# FITZSIMONS GATEWAY MULTIFAMILY | SITE PLAN

## AMENDMENTS

DATE:  
 08/24/22 - SITE PLAN 01  
 10/17/22 - SITE PLAN 02  
 11/23/22 - SITE PLAN 03  
 12/19/22 - SITE PLAN 04  
 02/13/23 - SITE PLAN 05  
 05/17/23 - MINOR AMD 01-1  
 12/08/23 - MINOR AMD 01-2

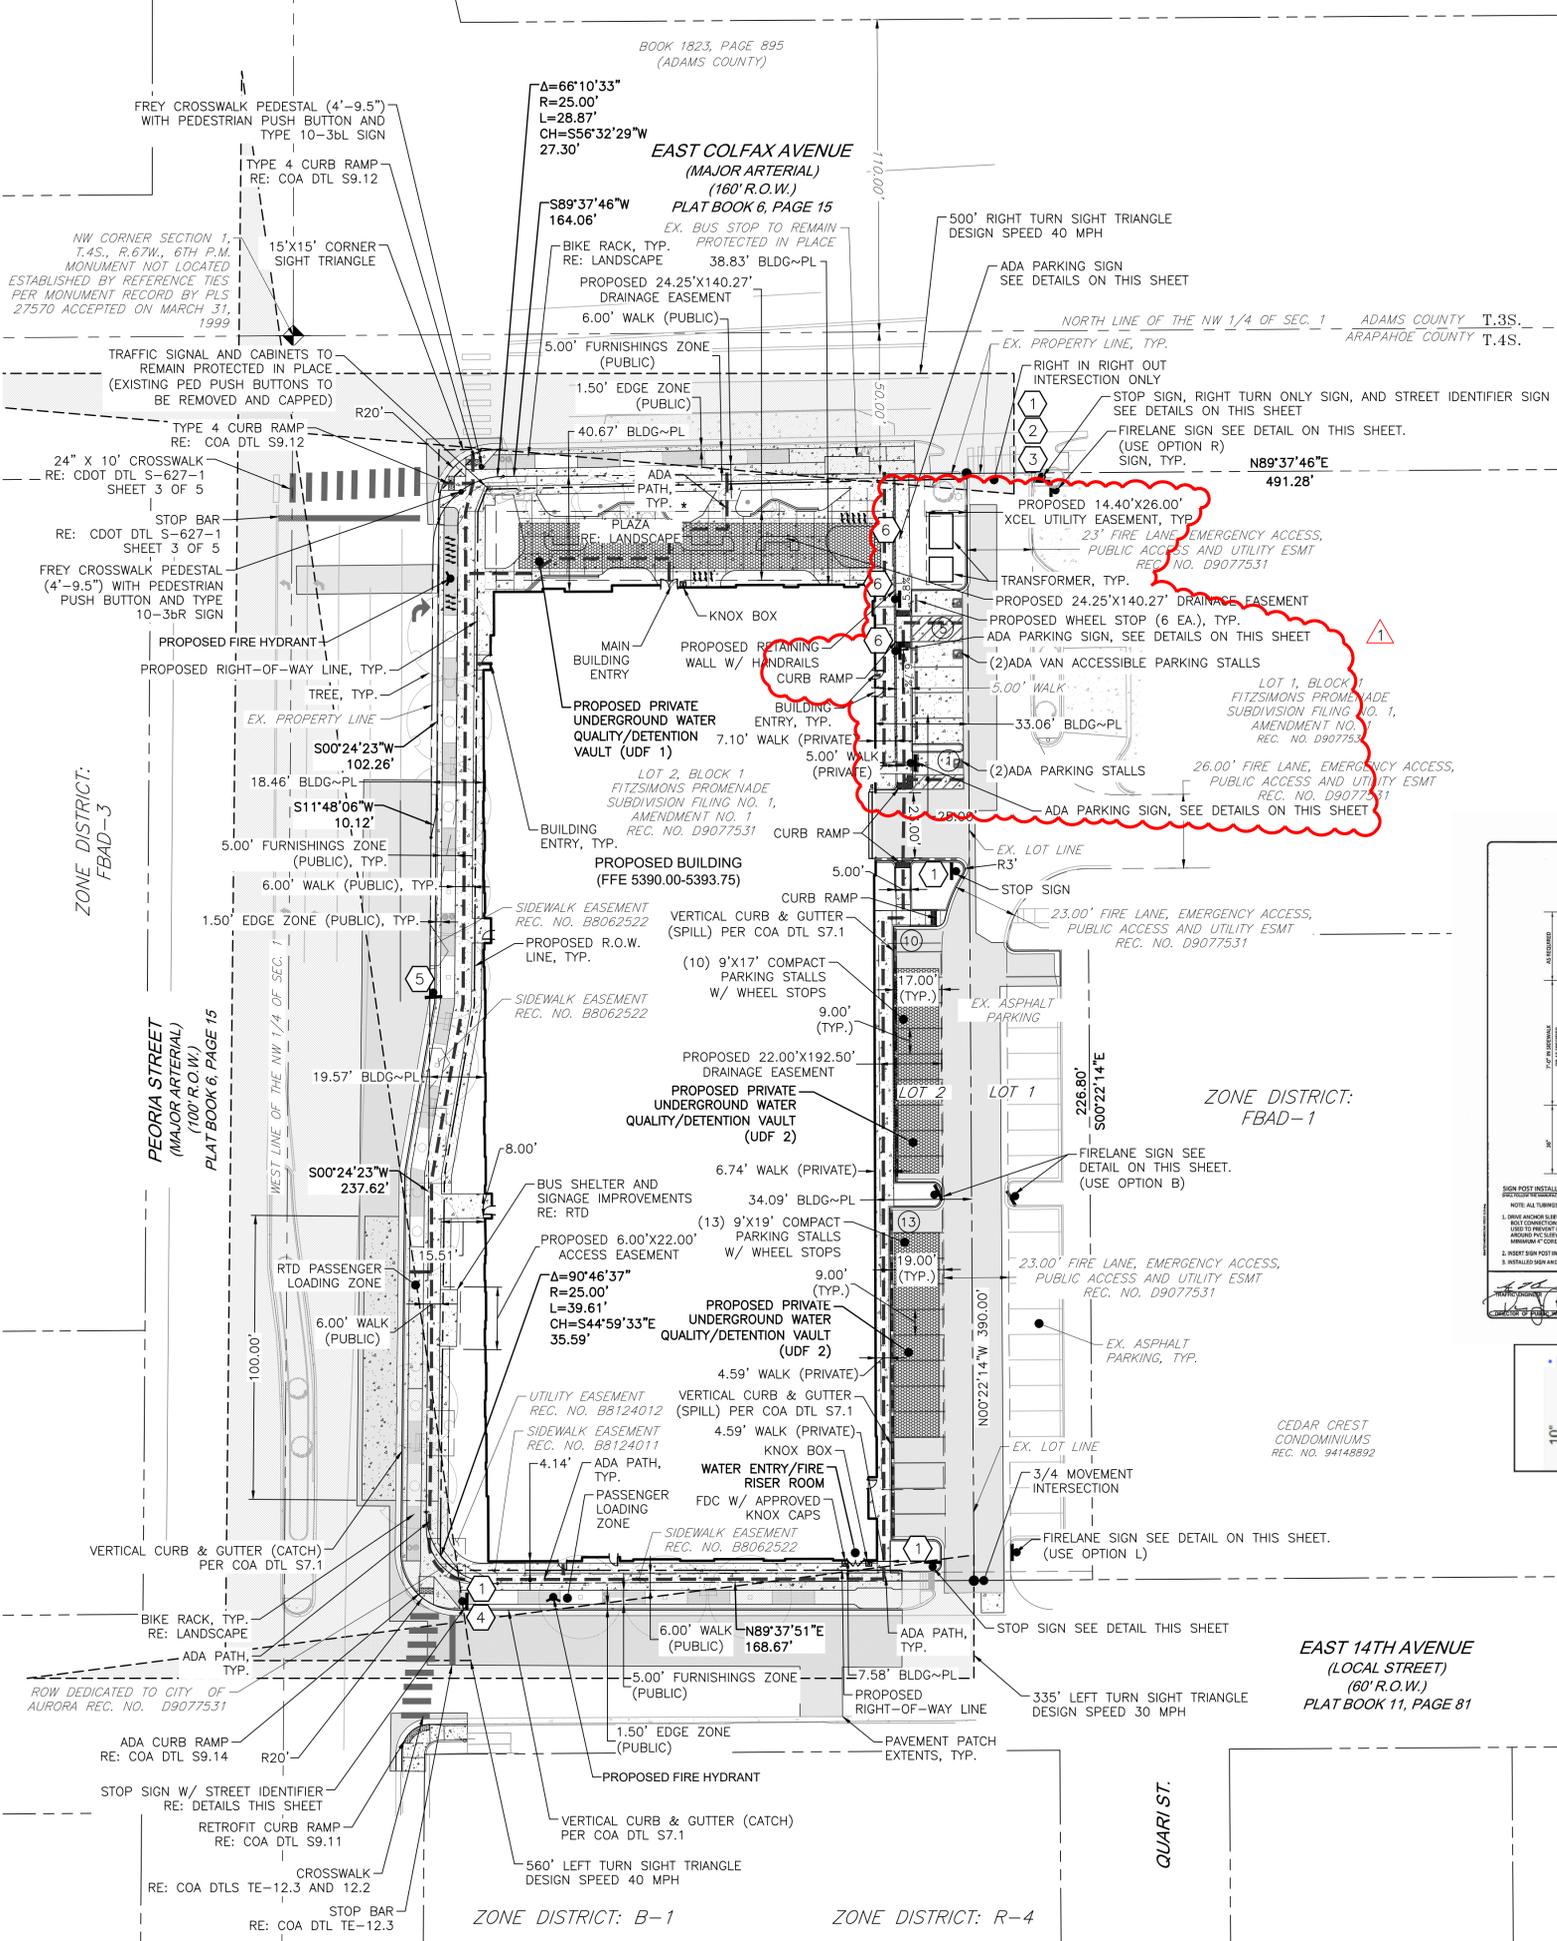
- 12/08/2023 MA: 2022-4047-01
  - TRANSFORMERS HAVE BEEN RELOCATED TO THE NORTH TO AVOID CONFLICT WITH STORMLINE AT PRIOR LOCATION; PARKING HAS BEEN RELOCATED TO THE SOUTH WITH NO CHANGES TO NUMBER OF STANDARD OR ACCESSIBLE SPACES. UPDATES SHOWN ON SITE PLAN, UTILITY & GRADING PLAN, HARDSCAPE PLAN, LANDSCAPE PLAN, LANDSCAPE ENLARGEMENTS, AND OVERALL PHOTOMETRIC PLAN.

- CURB RAMPS ADDED TO SITE PLAN SHEET TO SHOW ACCESSIBLE TRANSITION FROM ACCESSIBLE PARKING SPACES TO SIDEWALK ON THE EAST SIDE OF THE BUILDING. UPDATES SHOWN ON SITE PLAN, UTILITY & GRADING PLAN, HARDSCAPE PLAN, LANDSCAPE PLAN, LANDSCAPE ENLARGEMENTS, AND OVERALL PHOTOMETRIC PLAN.

**PLAZA LANDSCAPE ENLARGEMENT**

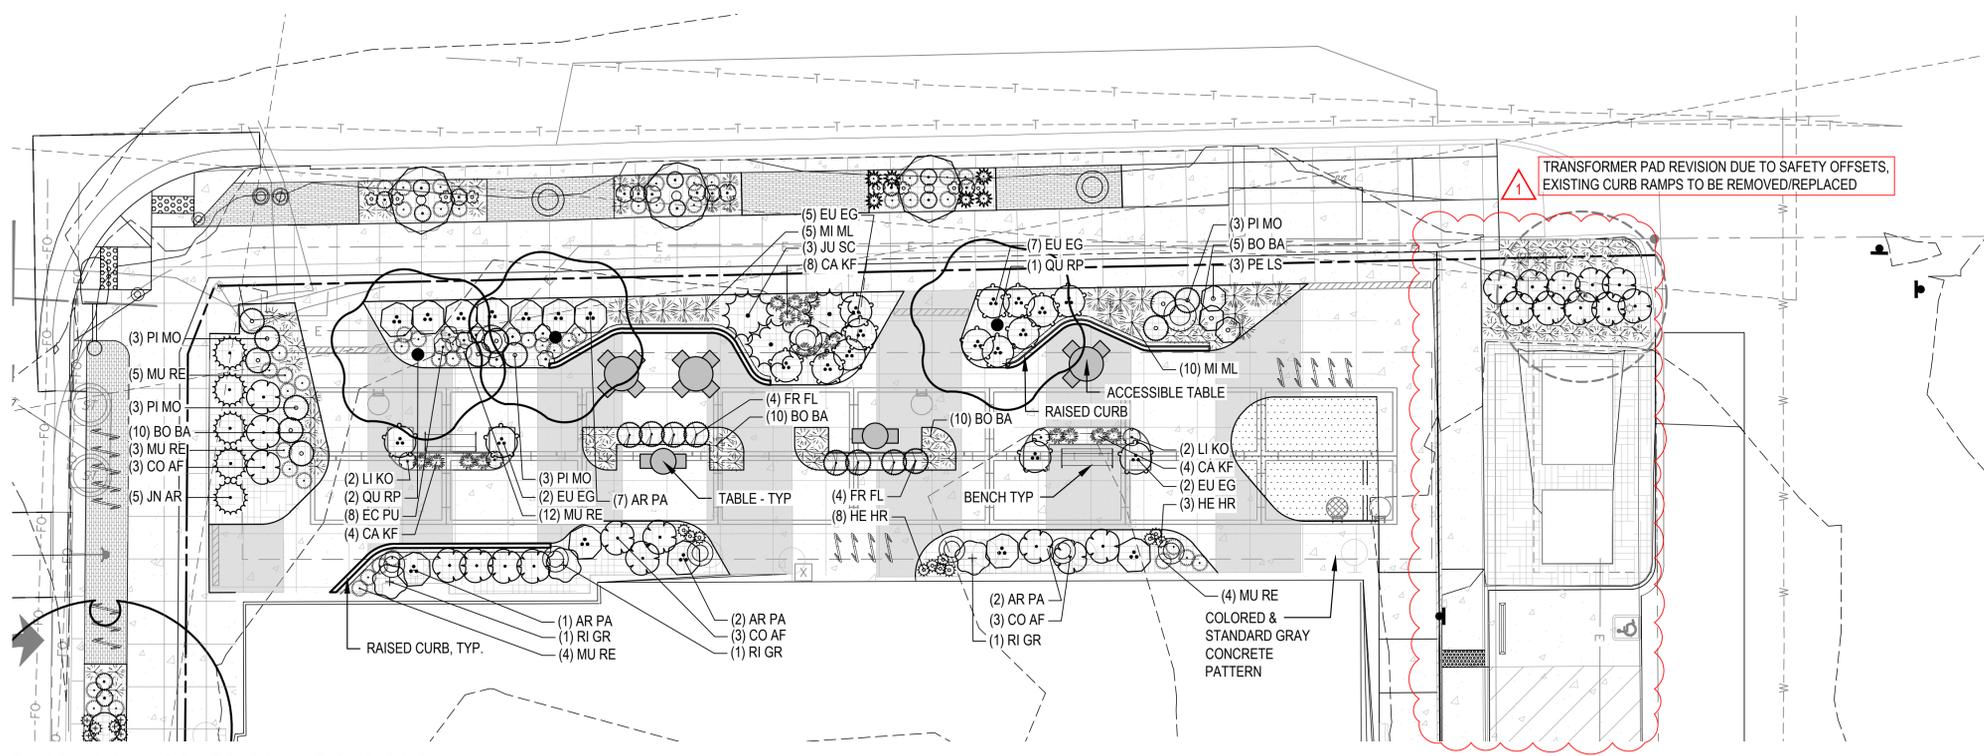
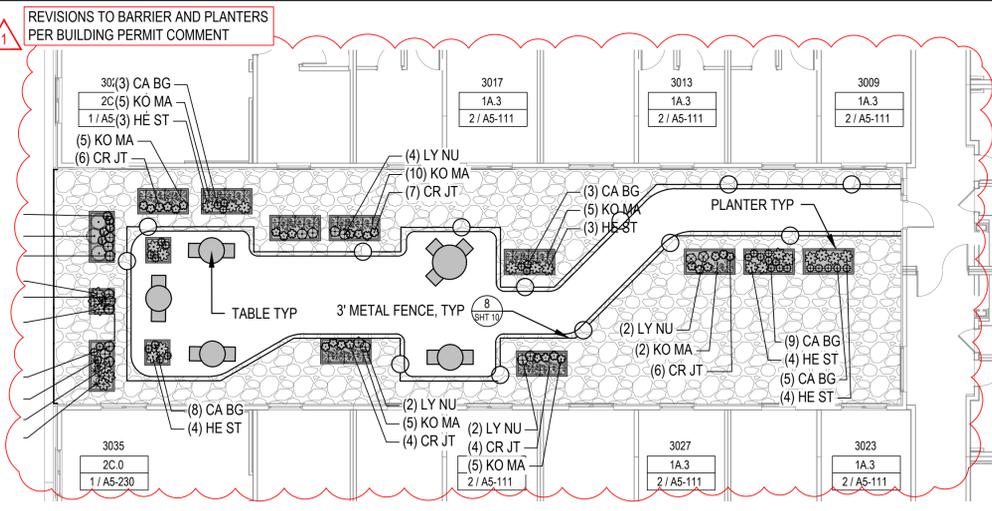
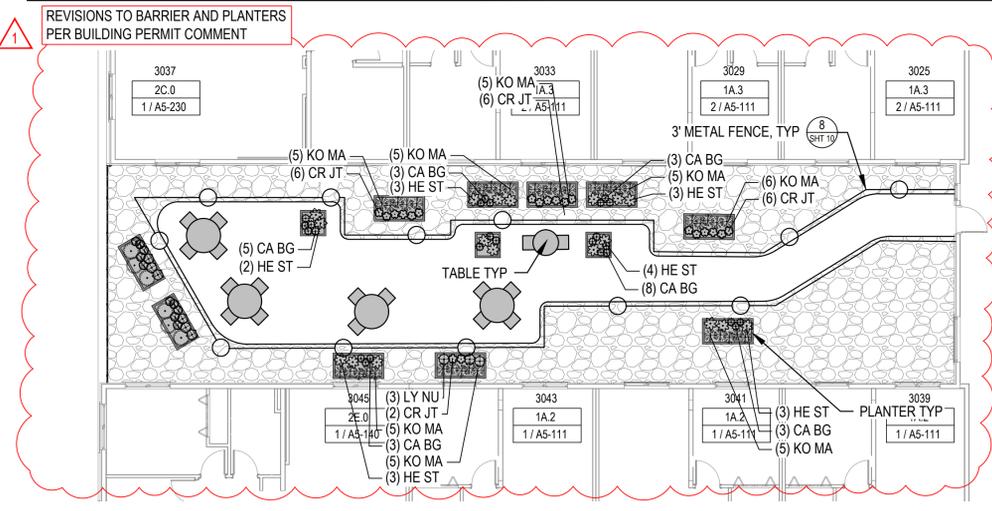
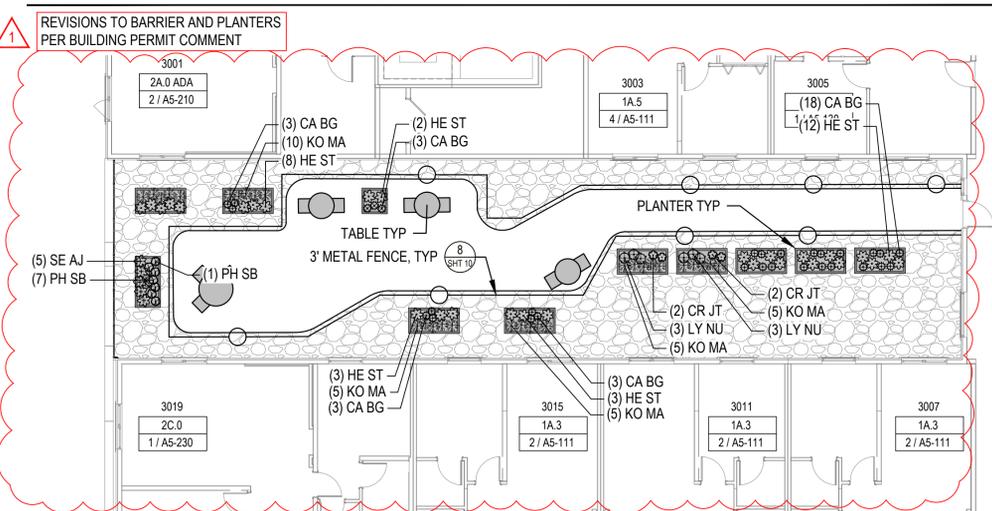
- AMENITY DECK LANDSCAPE PLANTERS AND FENCING REVISED PER COMMENTS RECEIVED DURING BUILDING PERMIT REVIEW. COBBLE REMOVED AND PLANTERS MOVED FURTHER FROM EDGE, FENCING DETAIL REVISED. UPDATES SHOWN ON LANDSCAPE ENLARGEMENTS, LANDSCAPE DETAILS, LEVEL 3 PHOTOMETRIC PLAN.

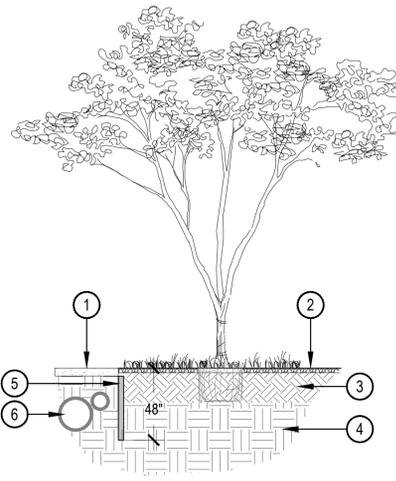
REVISIONS TO BARRIER AND PLANTERS PER BUILDING PERMIT COMMENT

**BUILDING ELEVATION - EAST**

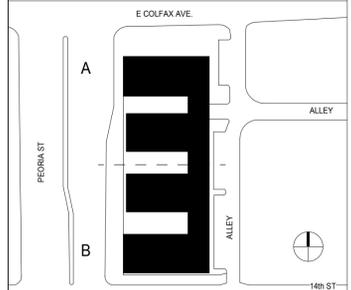
- PORTION OF MESH SCREENING ON EASTERN GARAGE ELEVATION HAS BEEN REMOVED TO PROVIDE INCREASED GARAGE VENTILATION AND REDUCED MESH MATERIAL AREA. UPDATE SHOWN ON EAST ELEVATION.

**1 SITE LIGHTING PHOTOMETRIC**  
SCALE: 1" = 30'-0"

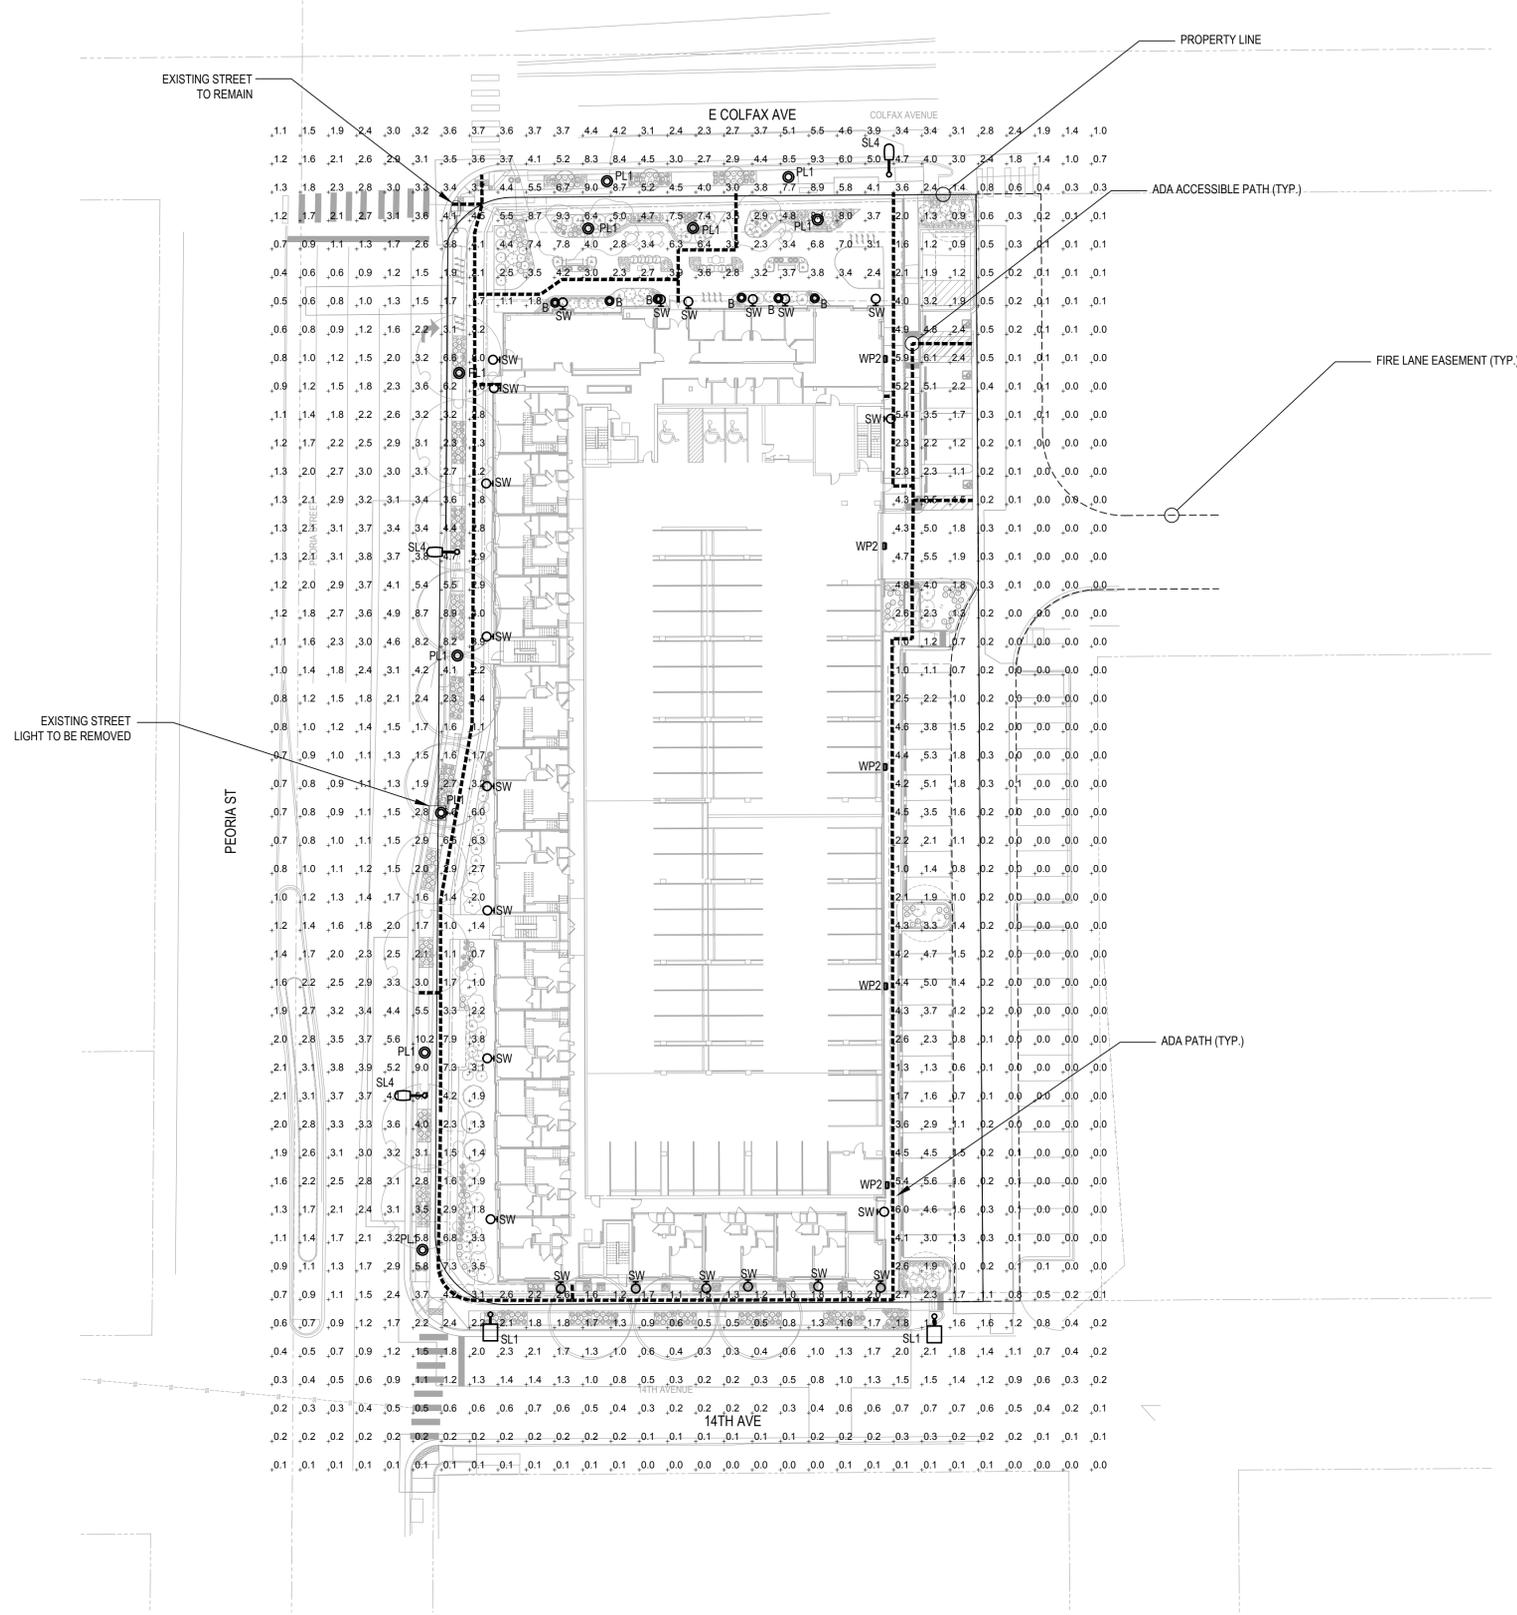
1 LIGHTING PLAN HAS NOT CHANGED, BUT UNDERLYING BASE DRAWINGS UPDATED TO REFLECT CHANGES WITH CIVIL AND LANDSCAPE DRAWINGS

1 LEVEL 3 PHOTOMETRIC  
SCALE: 1" = 30'-0"

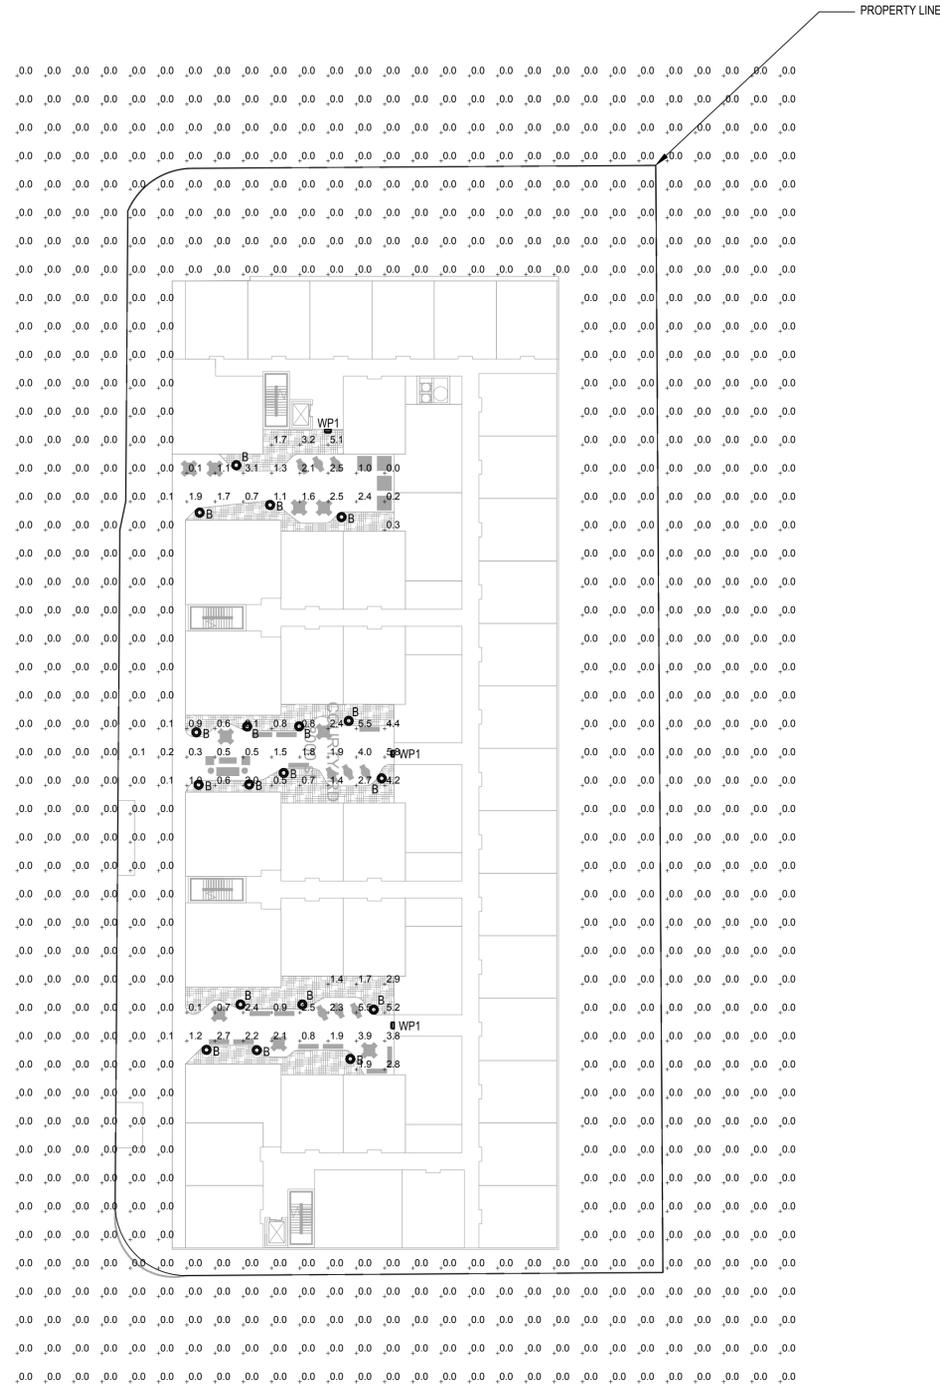
1 LIGHTING PLAN HAS NOT CHANGED, BUT UNDERLYING  
BASE DRAWINGS UPDATED TO REFLECT CHANGES  
WITH CIVIL AND LANDSCAPE DRAWINGS
